Design Review Board Meeting  
February 4, 2016  
Agenda Item: **3**

**To:** Members of the Design Review Board  
**From:** Planning Manager Watrous  
**Subject:** 2370 Paradise Drive; File No. VAR2015023/DR2015148; Site Plan and Architecture Review for Construction of a New Single-Family Dwelling, with Variances for Excess Lot Coverage and Excess Fence Height  
**Reviewed By:** \_\_\_\_\_

**ADDRESS:** 2370 PARADISE DRIVE  
**ASSESSOR'S PARCEL:** 059-191-05  
**FILE NUMBER:** VAR2015023/DR2015148  
**PROPERTY OWNERS:** RICHARD GREY  
**APPLICANT:** TURNBULL GRIFFIN HAESLOOPARCHITECTS  
**LOT SIZE:** 8,535 SQUARE FEET  
**ZONING:** R-2 (TWO-FAMILY RESIDENTIAL)  
**GENERAL PLAN:** HIGH DENSITY RESIDENTIAL  
**FLOOD ZONE:** X  
**DATE COMPLETE:** JANUARY 28, 2016

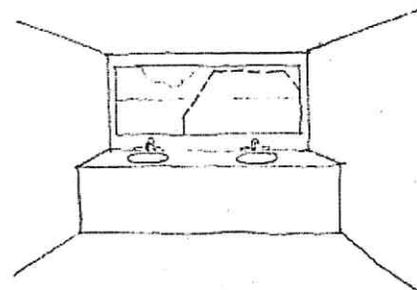
Goal 3, Principle 7 (A) of the Hillside Design Guidelines states that “view protection is more important for the primary living areas of a dwelling (e.g. living room, dining room, family room, great room, kitchen, and decks associated with these rooms) than for less actively used areas of a dwelling (e.g. bedroom, bathroom, study, office, den).” The raised roofline would intrude into the views from the kitchen and dining room of the home at 2380 Paradise Drive.

NO

• PROPOSED STRUCTURE  
BLOCKS LIVING ROOM VIEW -

• GREAT IMPACT ON  
LIVABILITY

YES

• PROPOSED STRUCTURE  
BLOCKS BATHROOM VIEW

• LITTLE IMPACT ON  
LIVABILITY

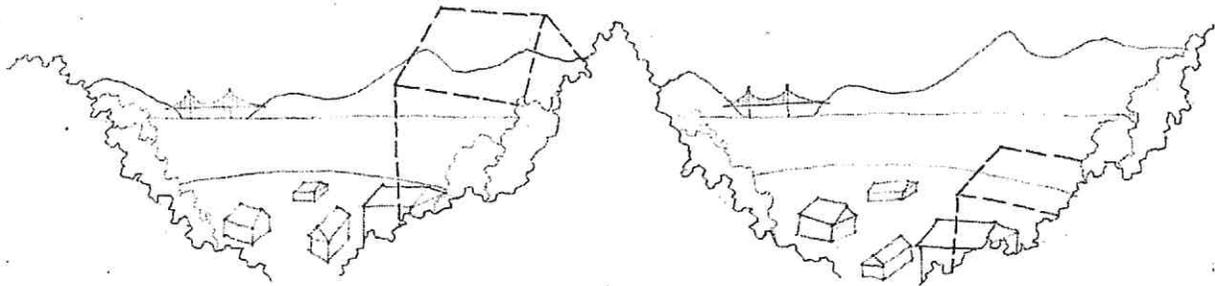
Goal 3, Principle 7 (C) of the Hillside Design Guidelines states that “horizon line is [the] most sensitive part of [a] view, then foreground, then middleground. If possible, avoid cutting [the] horizon line of a neighbor’s view.” The proposed raised roofline would cut

into the horizon line of the Marin Headlands and below the Golden Gate Bridge for the home at 2380 Paradise Drive.

NO

YES

6. BLOCKAGE OF CENTER OF VIEW MORE DAMAGING THAN BLOCKAGE OF SIDE OF VIEW.

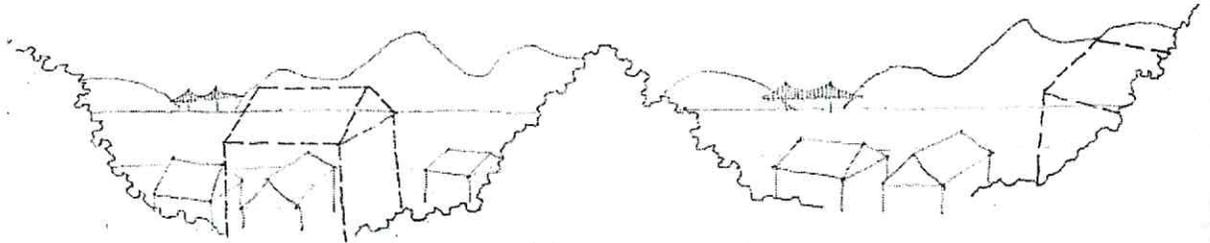
Goal 3, Principle 7 (C) of the Hillside Design Guidelines states that “blockage of center of [the] view [are] more damaging than blockage of [the] side of [the] view.” The raised roofline would intrude into the far right side of the view from the home at 2380 Paradise Drive.

• PROPOSED STRUCTURE  
BLOCKS CENTER OF VIEW

• PROPOSED STRUCTURE  
BLOCKS SIDE OF VIEW

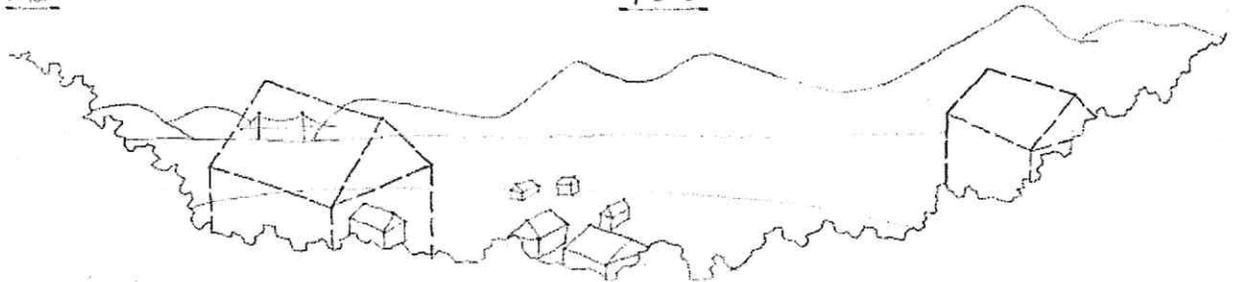
Goal 3, Principle 7 (D) of the Hillside Design Guidelines states that “blockage of important object in the view (Golden Gate Bridge, Belvedere Lagoon, Sausalito, Angel Island) is more difficult to accept than blockage of other, less well-known landmarks.” The raised roofline would intrude into the views of the Golden Gate Bridge from the kitchen of the neighboring home.

NO

YES

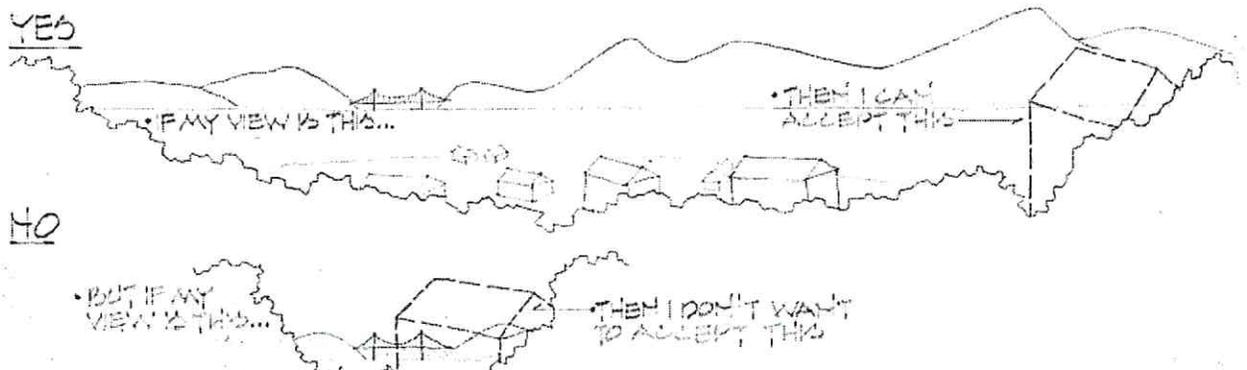
Goal 3, Principle 7 (E) of the Hillside Design Guidelines states that “a wide panoramic view can accept more view blockage than the smaller slot view.” The home at 2380 Paradise Drive has a wide panoramic view from the East Bay through Angel Island and San Francisco. The raised roofline would block only a small portion of the larger views from this neighboring residence. However, the roofline would intrude into almost the entire view from the kitchen of the home at 2380 Paradise Drive.

The lower portion of the roof of the proposed house would not appear to create the same view issues as the raised roofline. The story pole representing the lower roof above the proposed study would be similar to the profile of the existing house. Reducing the roofline above the living room, dining room and kitchen would likely alleviate this view concern.

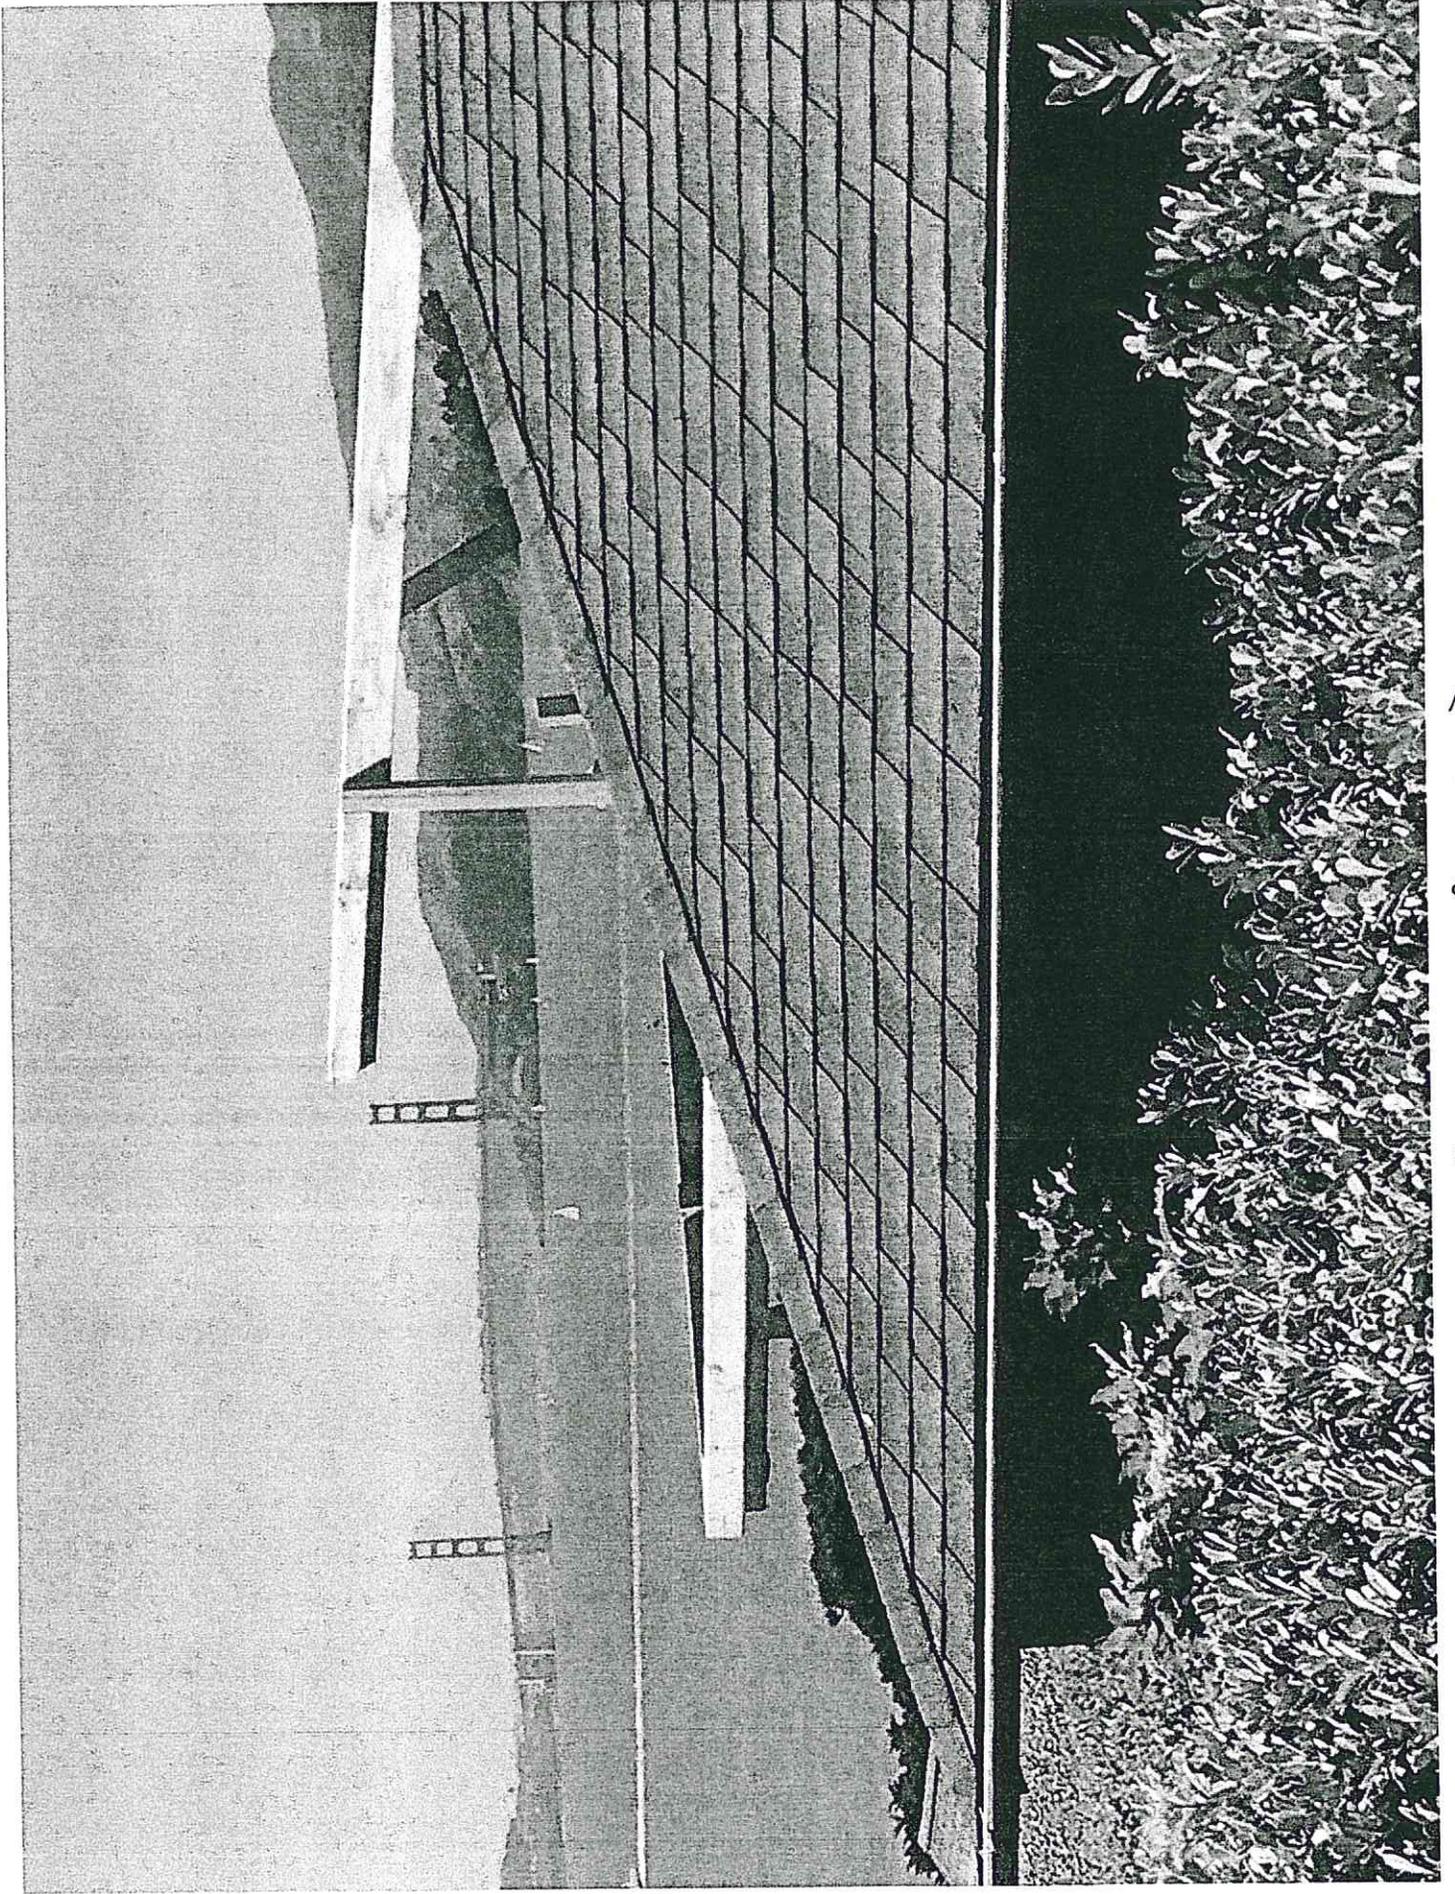
**PARADISE DRIVE PARKING** – Vehicles parked in our neighbor's parking pad too close to the end of our driveway obstruct our view of approaching cars and bicycles when we back out onto Paradise Drive. It is important that parked vehicles be able to pull completely off the road and not be able to pull up too close to our driveway. Some type of barrier to prevent parking close to our driveway would be good. There used to be a thick privet hedge at the end of the pad that prevented this. We have included a picture taken from our driveway of a truck parked in our neighbor's parking pad to illustrate the problem.
